**Monks Orchard Residents'
Association
Planning**

23rd May 2022

Reference: 21/06387/FUL
Application Received: Thu 30 Dec 2021
Application Validated: Tue 19 Apr 2022
Address: 395 Addiscombe Road Croydon CR0 7LJ
Proposal: Erection of four-storey building to provide 145.7sqm GP Surgery (Use Class E(e)) and nine (9) self-contained flats (following demolition of existing two-storey mixed-use building (Use Classes C3 and E(e)), Associated amenity, cycle storage, vehicle parking and waste storage spaces, and Associated alterations including landscaping and formation of boundary treatments
Case Officer: Demetri Prevatt
Ward: Addiscombe East
Consultation Close Date: Fri 27 May 2022
Determination Deadline: Tue 14 Jun 2022

Site Layout with Communal Garden Area and Play Space for Children.

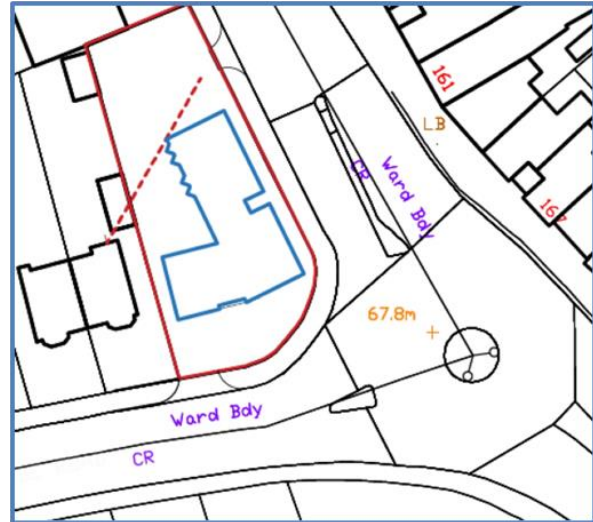
4.4.2 The Communal and Play Area as shown on the Site Layout, is combined at $(5.5 \times 5.4) + (5.5 \times 1.0) / 2 = \mathbf{32.45 \text{ sq.m.}}$. The **London Plan Policy S4 Play and informal recreation States:** *“for residential developments, incorporate good-quality, accessible play provision for all ages. At least 10 square metres of play space should be provided per child.* **The proposal therefore is totally inadequate for three reasons:**

a) The Play Space for Children is NOT separated from the Communal amenity Space.

b) The Play Space does NOT meet the requirement of **10sq.m. per child**. The probable number of children accommodated in the proposal would be ≈ 12 which in accordance with both the Revised Croydon Plan and The London Plan requires **10sq.m. per child which therefore requires 120 sq.m.**

c) The **Communal Open Space** plus the required **Play Space for Children** is not adequate and the **Site Capacity** is insufficient to provide adequate space and an appropriate proportion of area to be provided for this amenity requirement.
